ADDENDUM

Project Name:	Village of Beverly Hills Village Hall Office Renovation	Addendum No:	One (1)
Project Number:	15-161	Issue Date:	April 15, 2015
Project Location:	The Village of Beverly Hills, Michigan

To the Contract Documents for the requested Village of Beverly Hills Village Hall Office Renovation.

A0-04

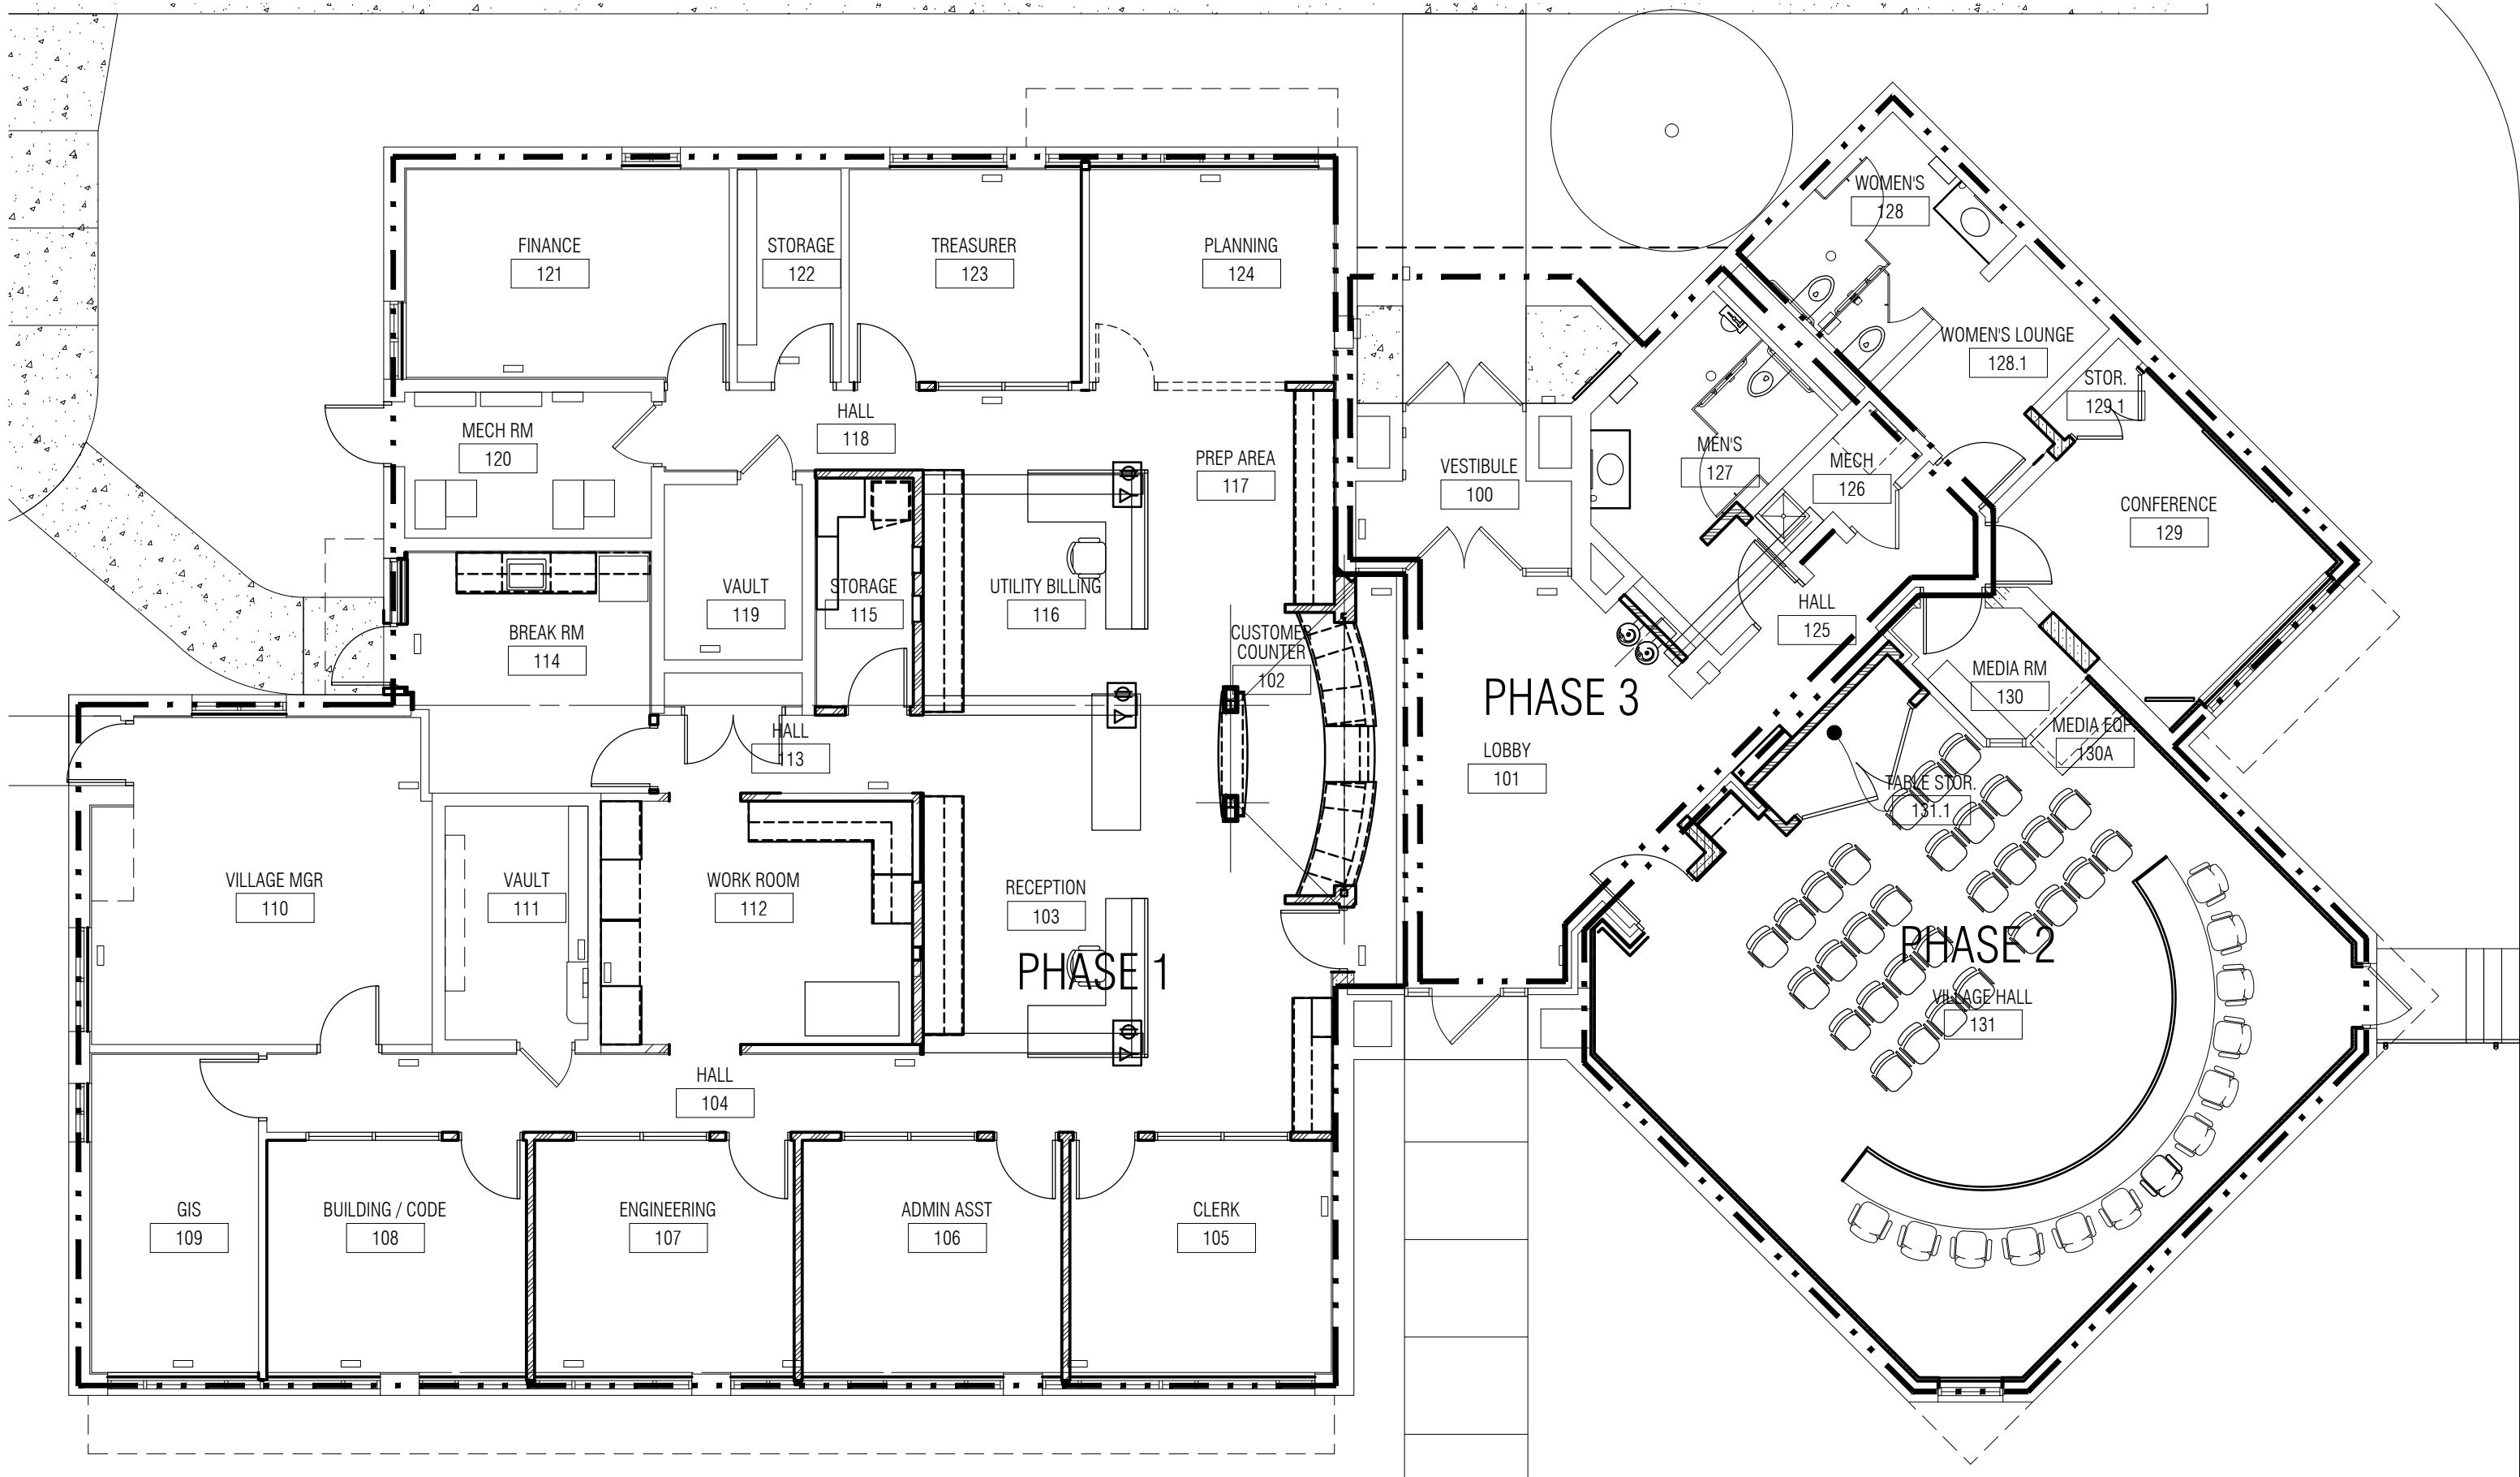
Item A2 Drawing A0-04; Schedules Frame Types, Door Types & Wall Types (revised and reissued this addendum)

- A. Revised Room Finish Schedule per reissued drawing.
 - a. Revised Floor Finish, Base, and ceiling finish as noted per addendum.
 - b. Revised Finish Schedule Legend as noted per addendum.

A1-01

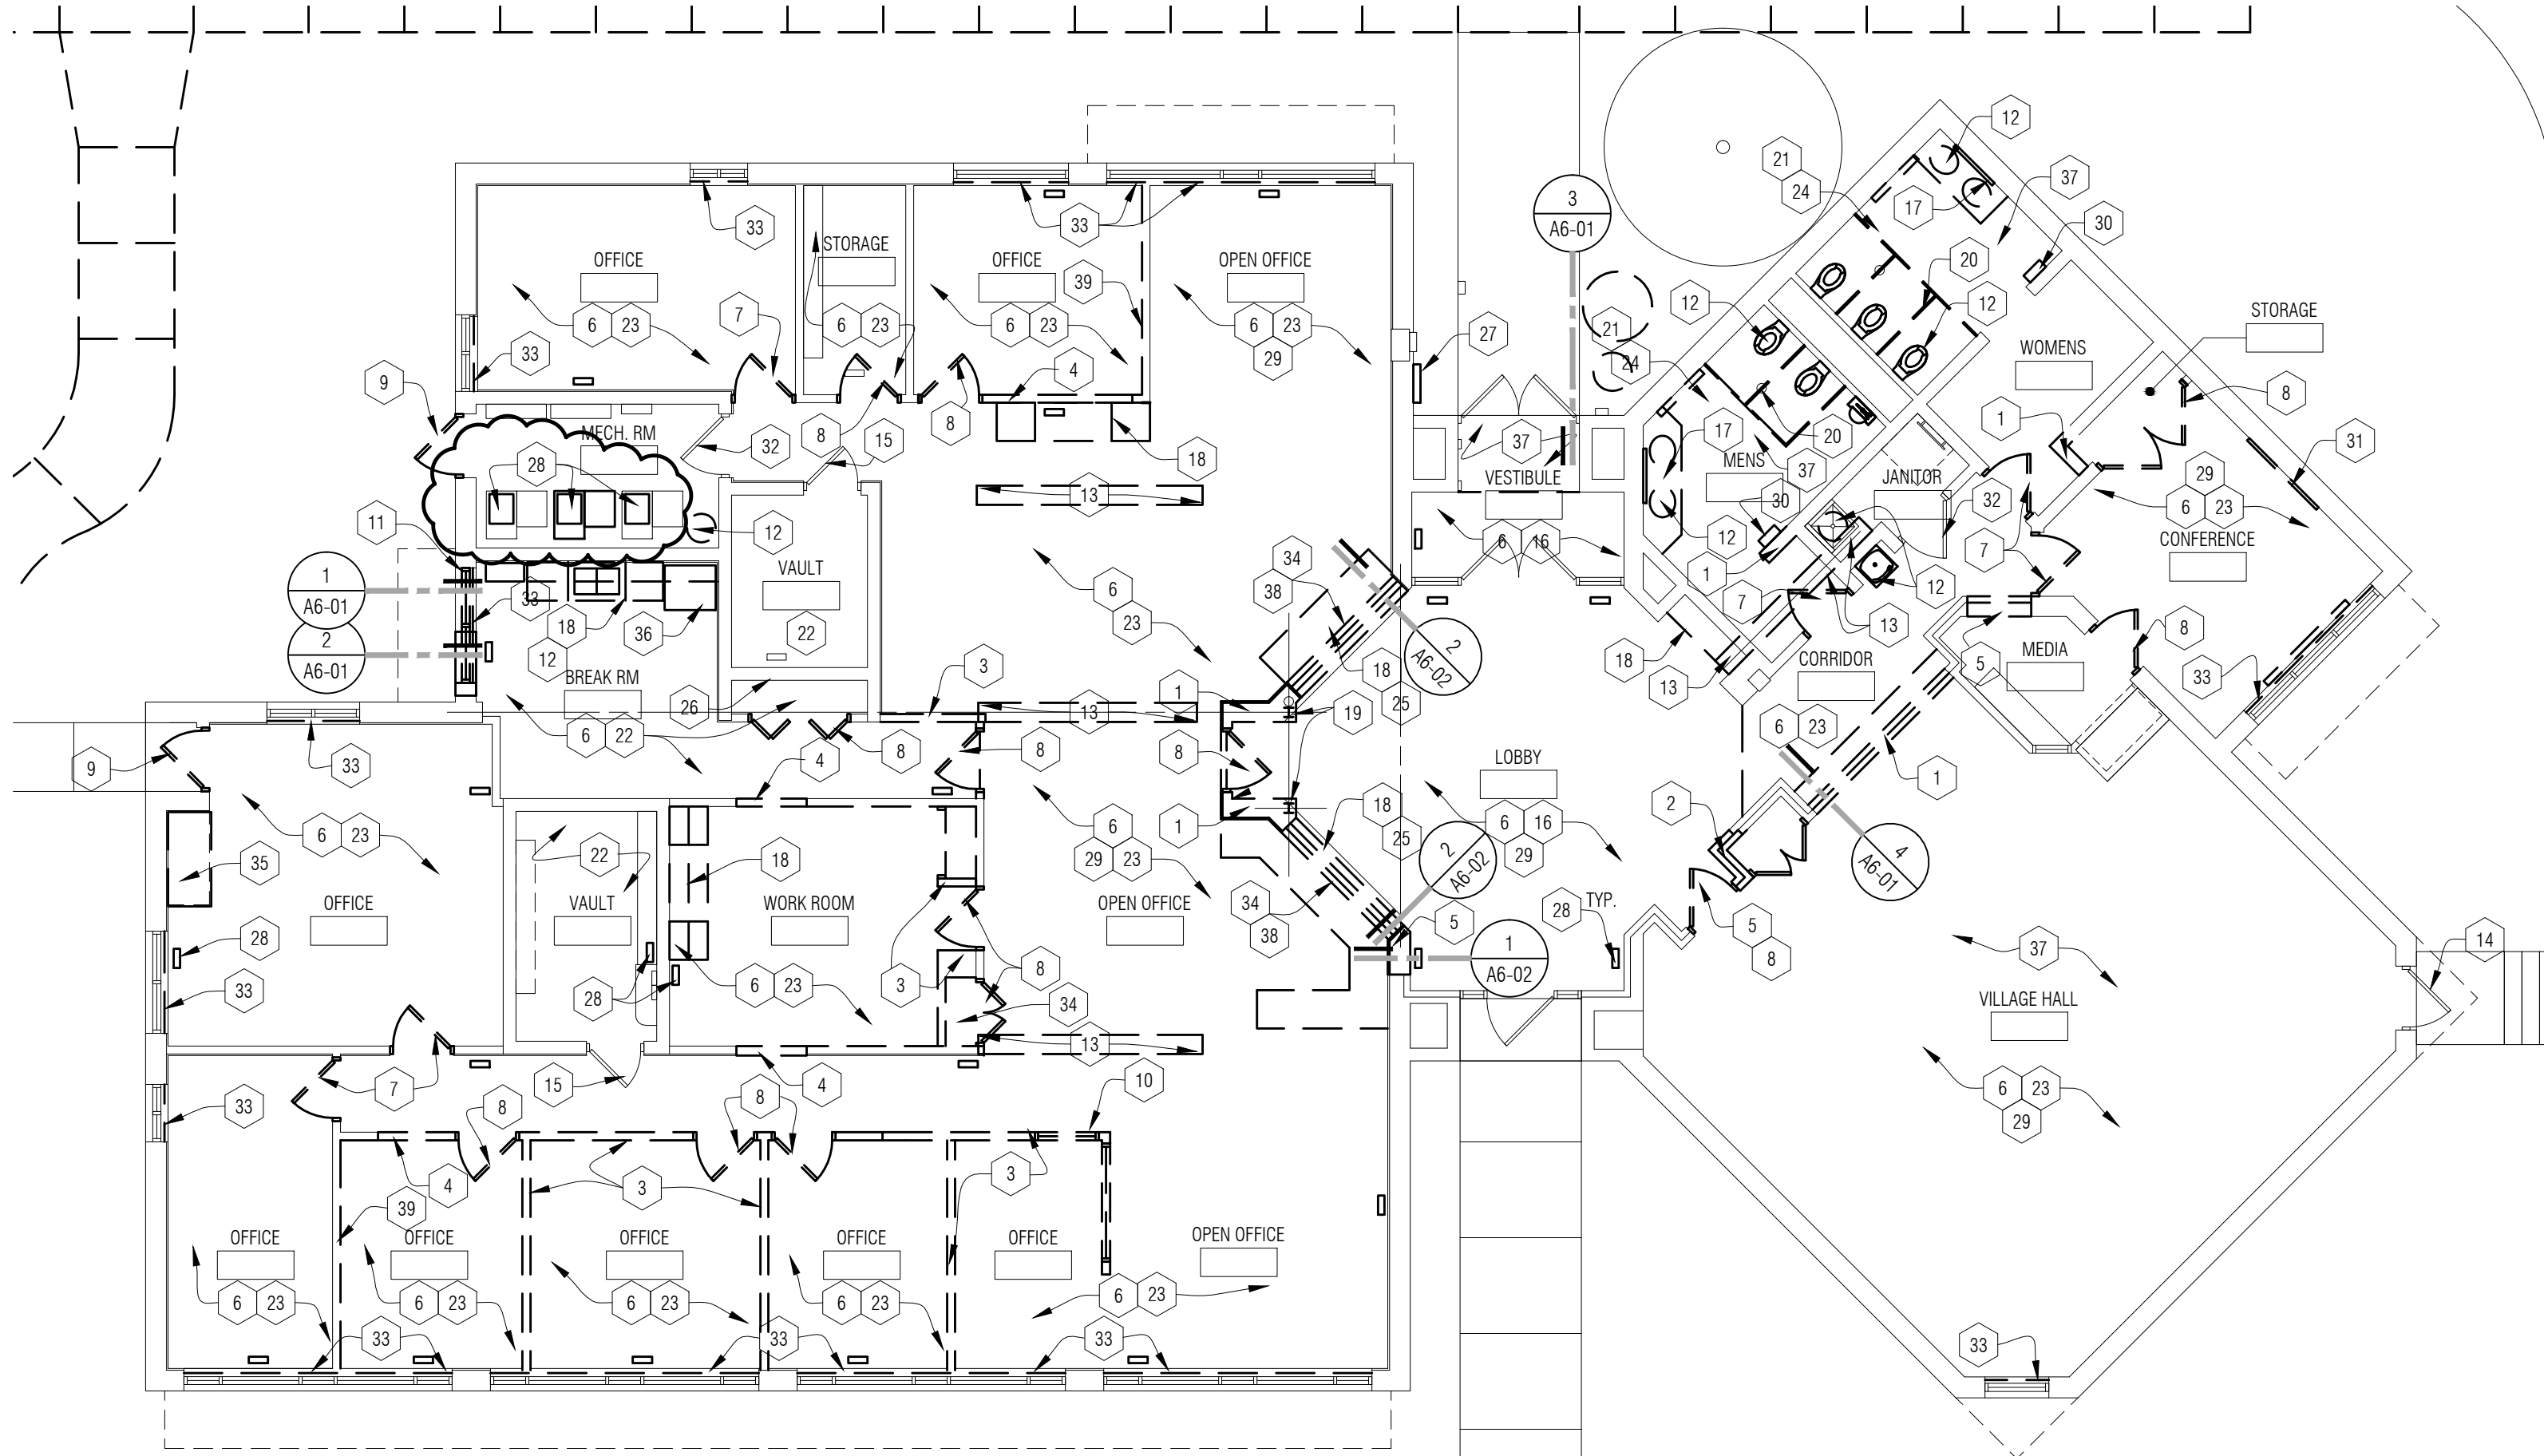
Item A3 Drawing A1-01; Floor Plan – Demolition and Phasing (revised & reissued this Addendum)

- A. Revise Demo Floor Plan - General Note “P” to read: Note: “Q” - Existing roof is under warranty. (Firestone "Red Shield" roofing system limited warranty #RD 079198). Protect roofing system from any and all damage. Modifications to

existing roofing system shall be performed by approved roofing contractor and existing warranty shall be maintained.

- B. Revised Demo Floor Plan Keynote # 28 to read: "Existing supply air plenum / ducts – rework and cap. Typical of 3 locations. Refer to new work detail 10/A6-03 & Mech." 9SK-04 issued per this addendum.
- C. Added new Demo Floor Plan Keynote # 40 to read: "Remove existing village informational display sign on south side of building, including concrete foundations and support posts. Existing electrical conduit to remain to connect power to new monumental sign installed in similar location."
- D. Revised Keynote # 27 on "Floor Plan – Demolition" in Mech Rm 120 to read keynote # 28.
- E. Add Keynote #40 to "Floor Plan – Demolition" at existing sign location.

- Q. EXISTING ROOF IS UNDER WARRANTY. (FIRESTONE "RED SHIELD" ROOFING SYSTEM LIMITED WARRANTY #RD079198). PROTECT ROOFING SYSTEM FROM ANY AND ALL DAMAGE. MODIFICATIONS TO EXISTING ROOFING SYSTEM SHALL BE PERFORMED BY APPROVED ROOFING CONTRACTOR AND EXISTING WARRANTY SHALL BE MAINTAINED.

- 28 EXISTING SUPPLY AIR PLENUM / DUCTS - REWORK AND CAP. TYPICAL OF 3 LOCATIONS. REFER TO NEW WORK DETAIL 10/A6-03, & MECH.
- 29 OWNER TO REMOVE AND SALVAGE ALL WALL HUNG PHOTOS, MAPS, PLAQUES AS REQUIRED- TYPICAL ALL AREAS.
